FAQ Number 16-0011 FAQ Revision 1

FAQ Title Cable Tray Ignition

Plant:	<u>Harris</u>	Date:	<u>June 2, 2016</u>
Contact:	<u></u>	Phone:	<u>(919) 546-4570</u>
	<u>Harold Stiles</u>	Email:	<u>Harold.Stiles@Duke-Energy.com</u>
	<u>Robert Cavedo</u>		<u>Robert.Cavedo@ExelonCorp.com</u>
	<u>Francisco Joglar</u>		<u>FJoglar@jensenhughes.com</u>
	<u>Kyle Christiansen</u>		<u>Chris1K@Westinghouse.com</u>
	<u>Young Jo</u>		<u>ygio@southernco.com</u>

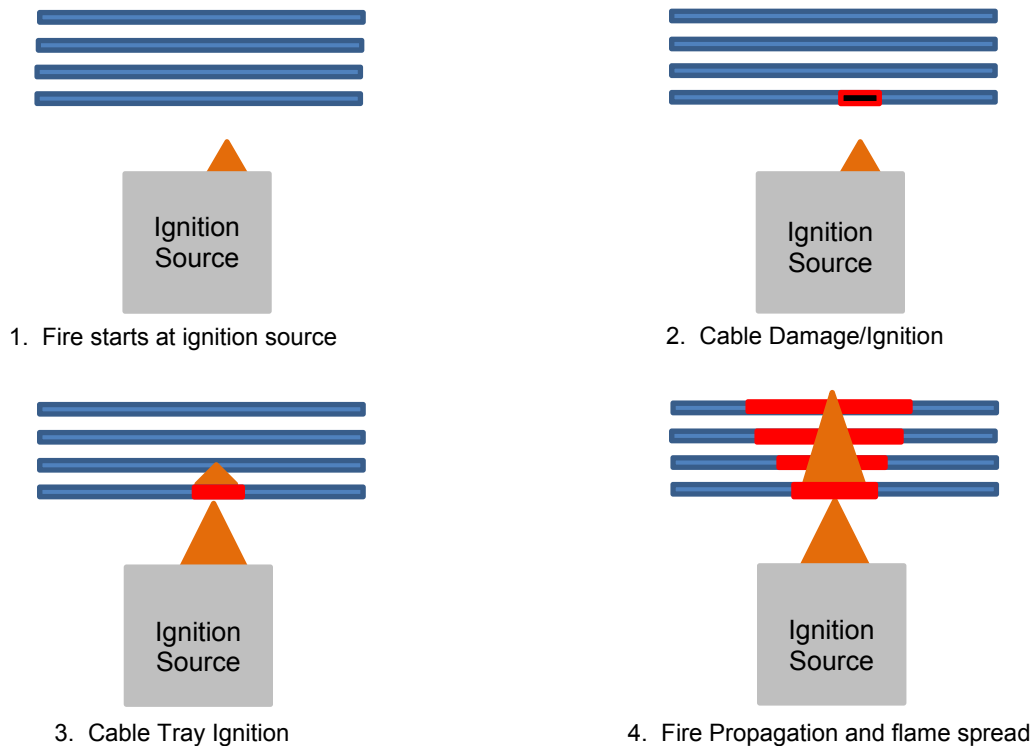
The following sequence provides a conceptual representation of the proposed scenario development for FPRA modeling purposes:

1. Ignition: Fire starts at ignition source generating a zone of influence affecting nearby cables in cable trays or conduits.
2. Cables in cable trays are damaged when exposed to thermal conditions exceeding the cable damage and ignition criteria listed in [Table 1Table 1Table 1](#). Localized ignition of cables can occur due to shorts; however, the exposures are insufficient to sustain a significant heat release rate (e.g. is a measurable fraction of the ignition source heat release rate). Assume cables are damaged by localized ignition regardless of their location within a cable tray/conduit arrangement if the thermal conditions at the location of the cable tray exceed the cable damage and ignition criteria listed in [Table 1Table 1Table 1](#).

3. If the analysis is applying the bulk cable/tray ignition criteria in [Table 1Table 1Table 1](#) (Method 2), or if the analysis is conservatively assuming bulk cable/tray ignition using the bounding thresholds listed in [Table 1Table 1Table 1](#) (Method 1), and the temperature or heat flux criteria for the applied method is exceeded, then, the resulting pyrolysis rates are sufficient that the entire length and width of the cable tray ignited begins to make a measurable contribution to the heat release rate of the ignition source. The length and width of the initial cable tray ignited used to calculate the heat release rate contribution should be determined following the guidance in Appendix R of NUREG/CR-6850 and/or NUREG/CR-7010 volumes 1 and 2.

4. Subsequent fire propagation and flame spread through a cable tray stack arrangement consistent with the guidance in NUREG/CR-7010, Vol 1.

The above sequence is recommended for growing fires only. The sequence is not applicable for high energy arcing fault fire scenarios. [Figure 1Figure 1Figure 1](#) provides a pictorial representation of the recommended sequence.
